OVERHAUL CHANGE NO. 8

CONNECTING ROD MODIFICATION

This change reflects all data and instruction in Franklin Service Bulletin No.99; consequently, a copy of the latter is not required.

Figure 8-1

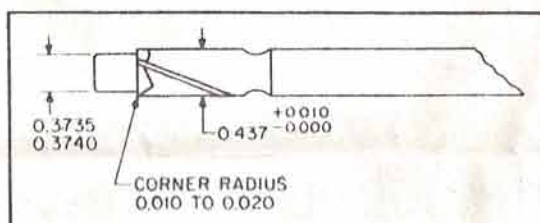
a. Procure a piloted counterbore tool similar to that shown in figure 8-1.

Figure 8-2

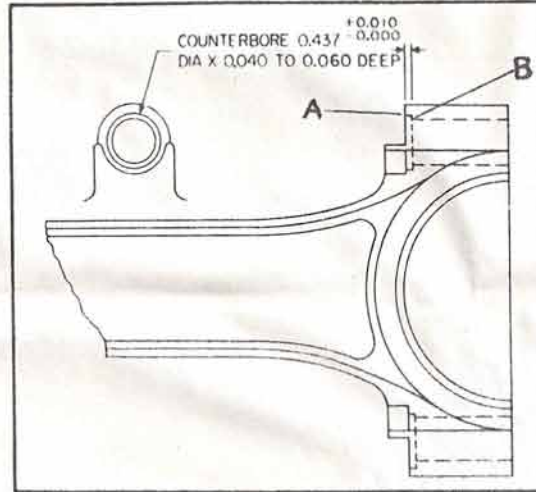
a. To provide instructions for modification of connecting rod assembly, part No. 17541, to prevent interference between the edge of the connecting rod bolt hole and the fillet of the connecting rod bolt head resulting in possible failure of the bolt.

b. Counterbore the blade half of the connecting rod at the bolt head end of both bolt holes to a diameter of 0.437 +0.010 inch in accordance with figure 8-2.
-0.000

c. Burr mouth of counterbore (A, Figure 8-2) using hand ball burr. Remove minimum stock.

d. Burr bolt hole edge (B, Figure 8-2) using 60° included hand burr. Remove minimum stock.
